Road Safety Audit Report

Incorporating
Stage 2 Completion of Detailed Design;
Design Organisation Response to items raised.

Proposed downgrade of A350 West Ashton Road and A350 Yarnbrook Road, Trowbridge

Client:
PFA Consulting

B.2.2 PROBLEM

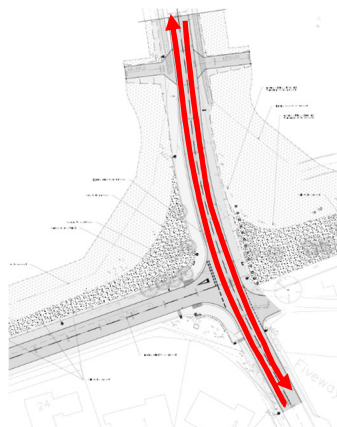
Location: Bratton Road

Summary: Increased vehicular speeds are likely to be observed on approach to West Ashton

Acc Type: Side impact collisions and loss of control type incidents

Bratton Road is mostly rural in nature but passes through a number of small villages providing a link between the A350 and B3098 which connects with the A360 and A303 to the southeast. It is likely that the road is utilised by some as a cut through. At present, southbound vehicles travelling along Bratton Road on approach to West Ashton, are subject to a 50mph speed limit which reduces to 40mph in proximity to the existing signalised junction with the A350 which acts as a traffic calming feature slowing traffic on approach the village where the speed limit reduces to 30mph. The proposals remove the existing signalised junction and replace it with a simple priority junction with Bratton Road as the major road. As such, following implementation of the proposals, no measures will be present that force vehicles to slow on approach to or exiting the village and as such, the proposals could give rise to incidents resulting from inappropriate speeds to include side impact collisions when a vehicle attempts to manoeuvre out of the old A350 priority junction when it is not safe to do so or loss of control type incidents due to heavy braking and the existing vertical alignment of the Bratton Road.

RECOMMENDATION:

It is recommended that a 30mph speed limit gateway is introduced just north of the proposed simple priority junction and that street lighting is extended to an appropriate location.

Agreed subject to TRO. The possibility of extending the 30mph and forming a 'gateway' has been agreed with WC. The 30mph 'gateway' will be where the existing 40mph starts on the north side of the junction. TRO Schedule to be revised.

B.3.1 PROBLEM

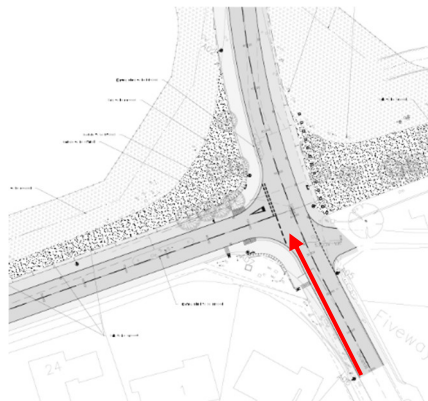
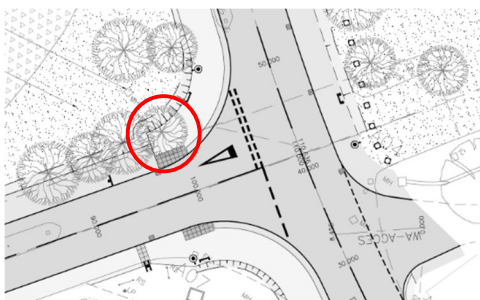
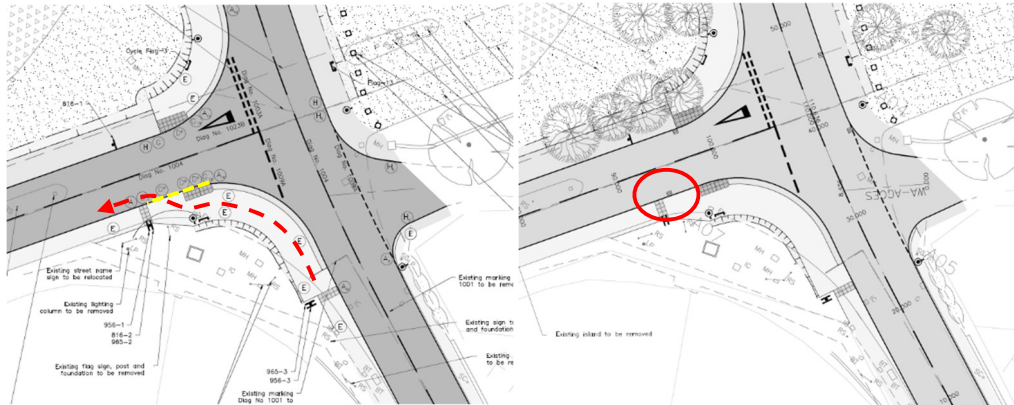
Location: Bratton Road

Summary: Proposed priority is likely to increase speeds on approach to the junction

Acc Type: Heavy braking and loss of control

Bratton road is set at a down gradient from south to north on approach to and through the signalised junction with the old A350. The existing northbound approach to the signalised junction benefits from high friction surfacing that appears to be in poor condition. It is proposed to downgrade the existing A350 carriageway to the west of the Bratton Road, stop up the A350 to the east of Bratton Road and provide a simple priority junction in place of the existing signalised junction. Visibility to and from the proposed simple priority junction is of a good level, however due to the down gradient, heavy braking could give rise to skidding and loss of control type incidents.

It is recommended that the northbound Bratton Road approach to the junction benefits from high frictional properties to aid braking.

Agreed. HFS to be extended across width of junction or resurface with PSV68+. Resurfacing of existing HFS is a maintenance issue for WC, but will be discussed accordingly.
